ATTACHMENT A

MARKUP TECHNICAL SPECIFICATION PAGES
FOR FACILITY OPERATING LICENSES
DPR-19 AND DPR-25

ATTACHMENT B

REVISED TECHNICAL SPECIFICATION PAGES
FOR FACILITY OPERATING LICENSES
DPR-19 AND DPR-25

3/4.9-16

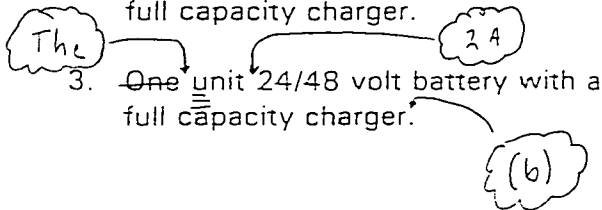
D. D.C. Sources - Shutdown

D. D.C. Sources - Shutdown

As a minimum, the following D.C. electrical power sources shall be OPERABLE:

The required batteries and chargers shall be demonstrated OPERABLE^(a) per the surveillance requirements in Specification 4.9.C.

1. One station 250 volt battery with a full capacity charger.
2. One station 125 volt battery with a full capacity charger.

1. One station 250 volt battery with a full capacity charger.
2. One station 125 volt battery with a full capacity charger.
3. The Unit 2A 24/48 volt battery with a full capacity charger.^(b)
